Office Action Summary	Application No. 10/537,937	Applicant(s) EGNER-WALTER ET AL.	
	Examiner MICHAEL P. FERGUSON	Art Unit 3679

DETAILED ACTION

Fig. 1

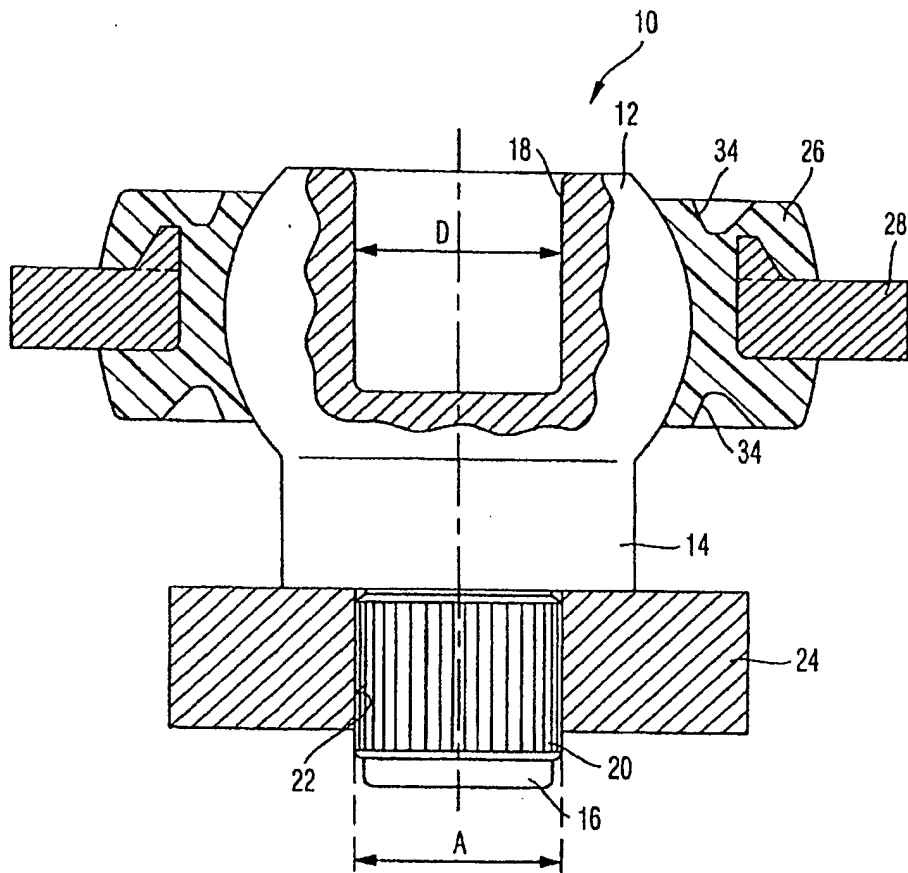
Elements **30,32**, shown in cross-sectional view in Figures 2, 4 and 5 of the replacement drawings filed October 11, 2007, lack proper cross-hatching based on the material of such elements. Accordingly, the replacement drawings have not been approved.

NOT
APPROVED.
NTP
1/16/08

Corrected drawing sheets in compliance with 37 CFR 1.121(d) are required in reply to the Office action to avoid abandonment of the application. Any amended replacement drawing sheet should include all of the figures appearing on the immediate prior version of the sheet, even if only one figure is being amended. The figure or figure number of an amended drawing should not be labeled as "amended." If a drawing figure is to be canceled, the appropriate figure must be removed from the replacement sheet, and where necessary, the remaining figures must be renumbered and appropriate changes made to the brief description of the several views of the drawings for consistency. Additional replacement sheets may be necessary to show the renumbering of the remaining figures. Each drawing sheet submitted after the filing date of an application must be labeled in the top margin as either "Replacement Sheet" or "New Sheet" pursuant to 37 CFR 1.121(d). If the changes are not accepted by the examiner, the applicant will be notified and informed of any required corrective action in the next Office action. The objection to the drawings will not be held in abeyance.
